BOARD OF APPEALS, CITY & COUNTY OF SAN FRANCISCO

Appeal No. **25-049**

NOTICE OF APPEAL

PRELIMINARY STATEMENT FOR APPEAL NO. 25-049

FIRST FLOOR / FOUNDATION PLAN

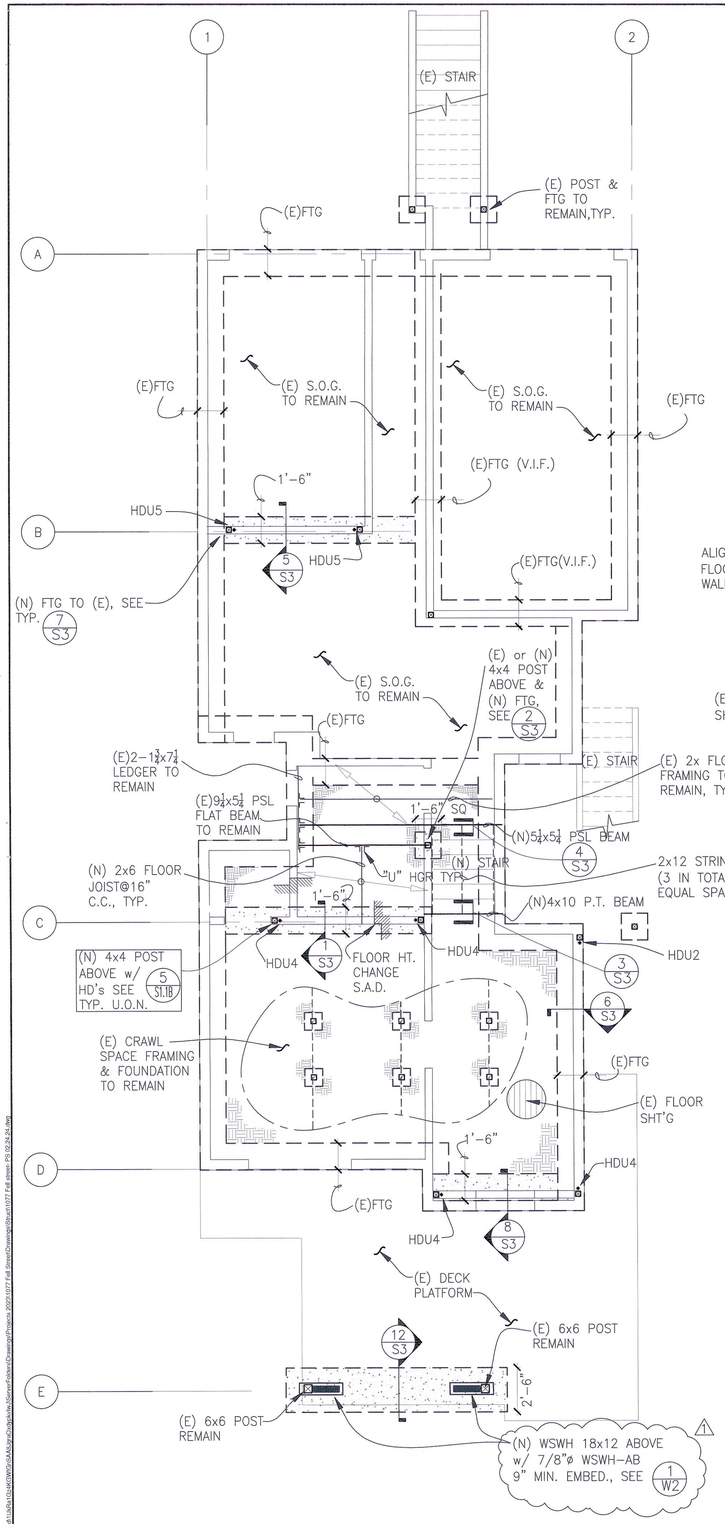
EXISTING FOOTING CONDITION SHOULD BE LIKE DETAIL 6/S3
MODIFY THE NEW FOUNDATION TO ACCOUNT FOR THE EXISTING FOOTING CONDITION. IT SEEMS THE FOOTING WILL BE MORE THAN 1'-6" DEEP

Line E Foundation check - FTG1

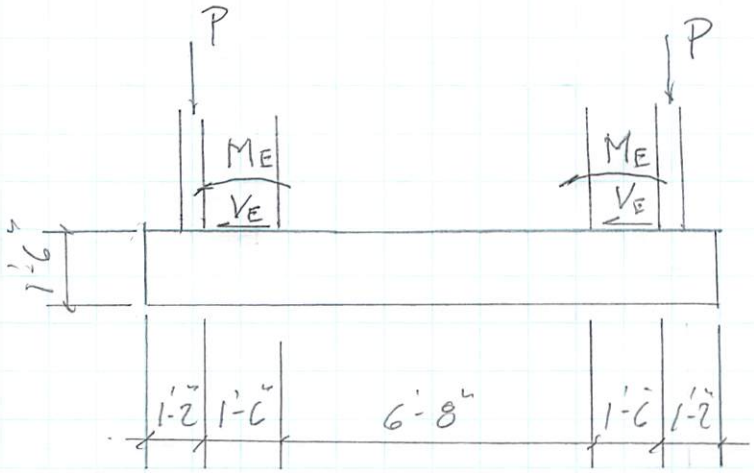
6. Enertia's Plans include a new Simpson Strong Wall at Line E which is supported on a new concrete footing. Code requires that this footing is designed for all code forces including earthquake forces. Enertia's calculations (**Exhibit 2 Calc. Sh. 27**) omitted the earthquake forces from the footing design and no calculations for the two other new shear wall footings were provided. **Exhibit 2** Calc. Sh. 15 show incorrect floor heights of 9 feet when architectural drawings show them at 11 ft. **Exhibit 3** Sh. S2 contains Chiawang Yeh's comment that the architectural elevation does not match the calculation and the strong wall height needs to be verified. **Exhibit 5** Calc. Sh. 10 and Sh. 13 show the 2025 calculations still use incorrect floor heights of 8 feet.

7. My calculations show that with earthquake forces included, the newly constructed footing will fail during a code level earthquake (**See Exhibit 7 Fn 6-15**). To make the new footing comply with code, it would need to be 16 ft long instead of the 12 ft provided. This footing should be modified to satisfy the code requirements.

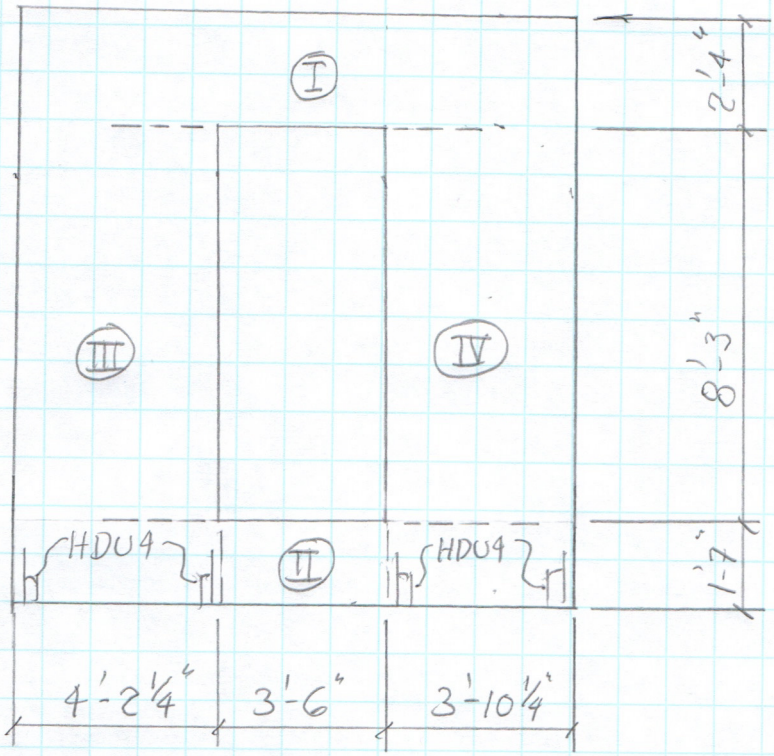
(Do not match calc's pg. 15 May 27, 2025)

Wood Shear Wall

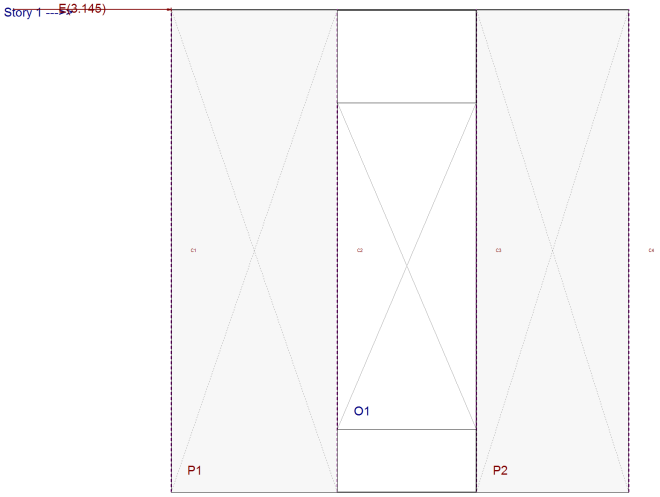
14. Enertia's 2024 Plans showed a window at Line D. (See **Exhibit 3 Sh. S2**) However, the contractors cut an opening for a 3'-6" x 8'-3" door opening in the wall. (See "**Exhibit 12**"). Enertia was required to address this opening size in the 2025 Plans, but Enertia did so incorrectly. The calculations by Enertia used a program called EnerCalc, which I also use. Enertia did not include the horizontal earthquake load in this program. Horizontal earthquake forces tip (overturning) walls over unless they are properly anchored to the floor. I included the earthquake forces in my calculations and found that the solid wall panels on each side of the door jamb require a hold-down (See **Exhibit 7** at P2). Without these hold-down anchors, the perforated shear wall potentially fails and tips over.

1. **42 inch width**

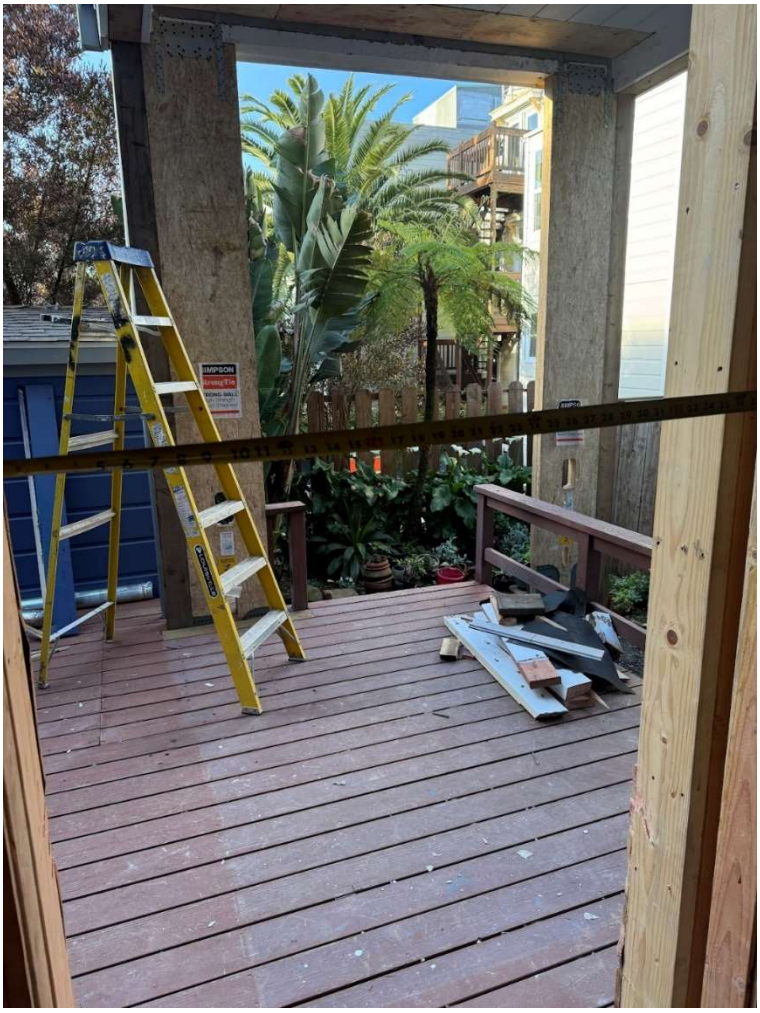
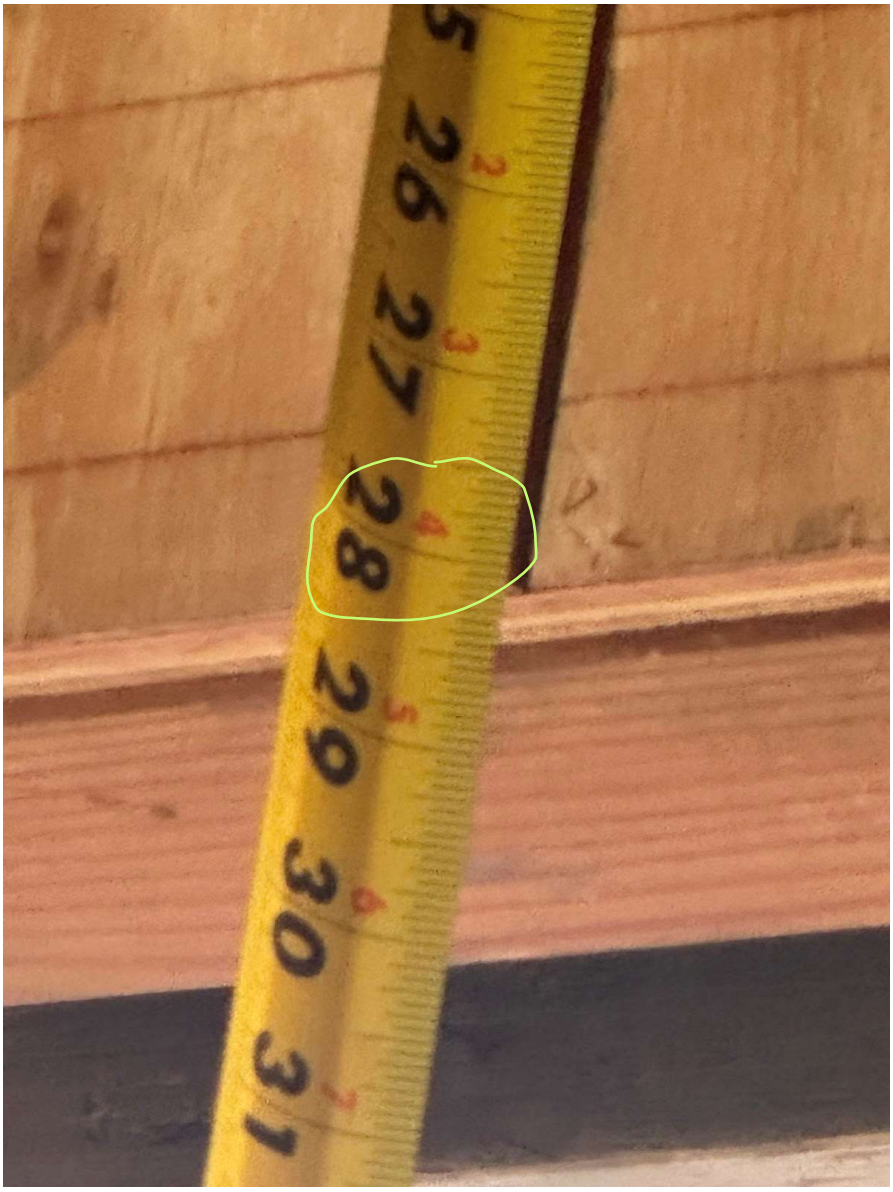
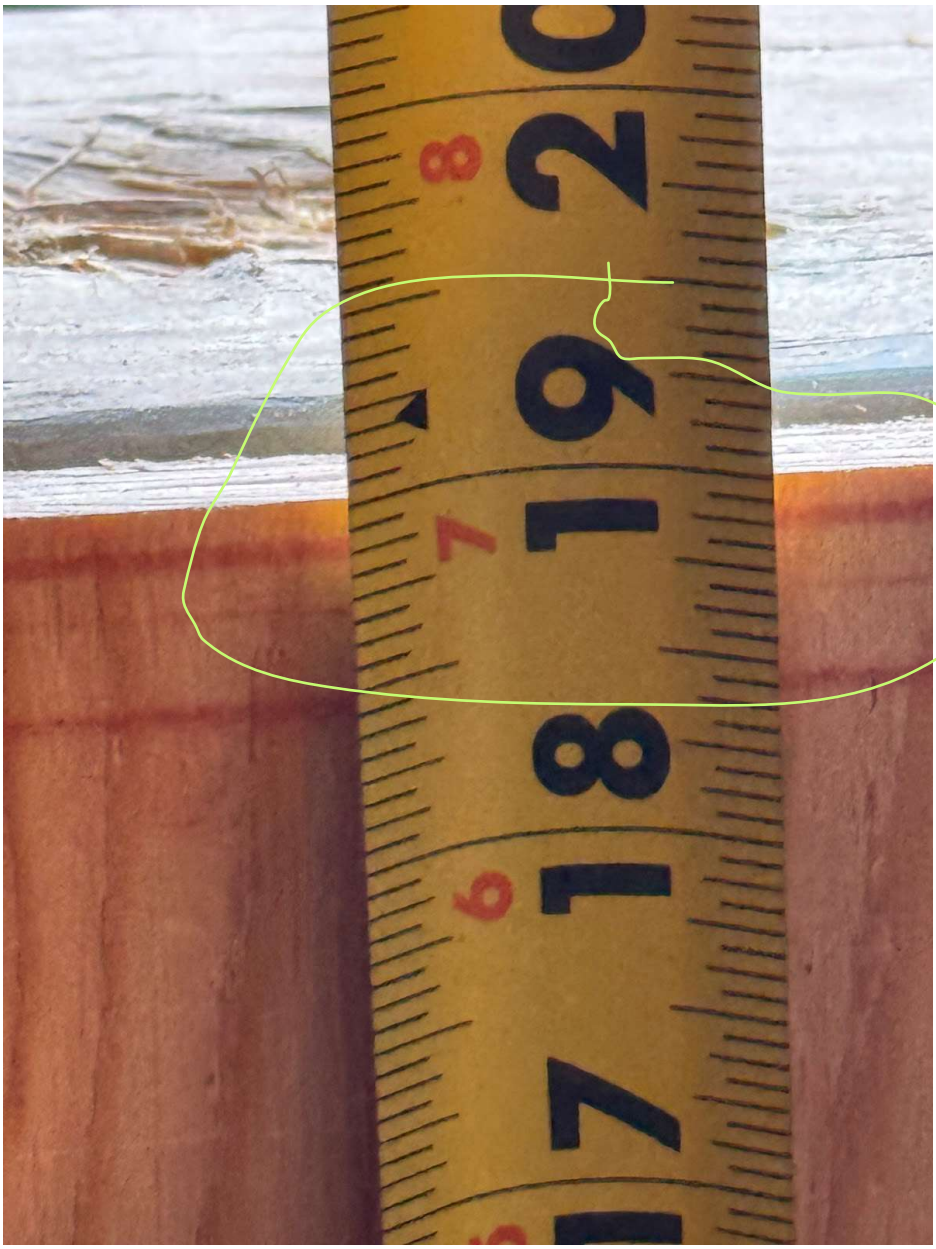
15. The section 8/S3 on Enertia's structural drawings do not show the correct conditions. The shear wall is shown to sit on the floor, but in reality it extends past the floor 15 inches or so and sits directly on the new footing. This makes the shear wall taller and changes the overturning forces. (See **Exhibit 6** Section 8 on S-3)

3. Shear wall height left above rough opening.

4. Shear wall extends below floor.
